Technical Service Bulletin

19 Coolant warning light on OR Coolant pump replaced due to a coolant leak - 4.0 TFSI

19 24 52 2065040/4 February 19, 2024. Supersedes Technical Service Bulletin Group 19 number 24-48 dated January 30, 2024 for reasons listed below.

Figure 1. Mechanical coolant pump.

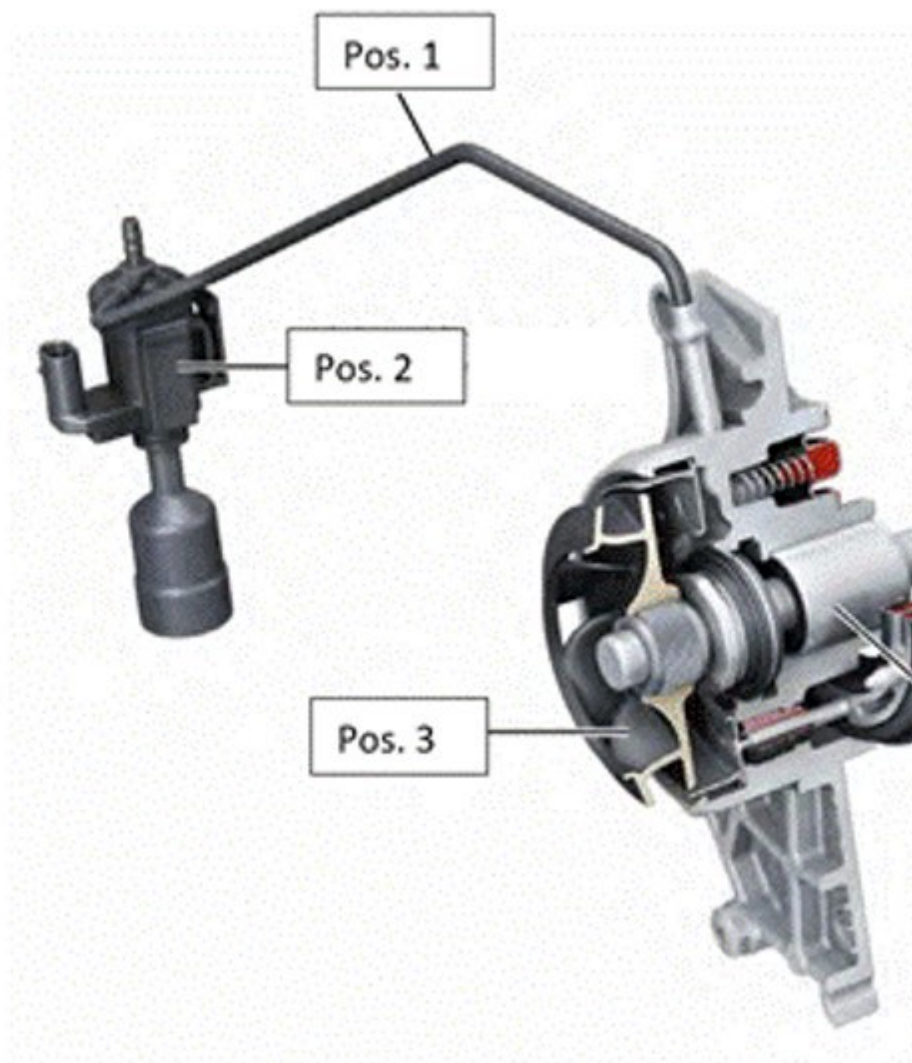
When performing work on the cooling system which requires the mechanical coolant pump to be replaced, it must be ensured that there is no coolant residue or fluid in the control line (Figure 1, position 1.) If there is, switch valve N649 must also be replaced in addition to the coolant pump and the control line must be cleaned/dried.

- Position 1 – control line.
- Position 2 – switch valve for mechanical coolant pump N649.
- Position 3 – mechanical coolant pump.

If coolant can be detected beyond the N649 switch valve, replace any components connected to the vacuum system that show signs of coolant ingress.
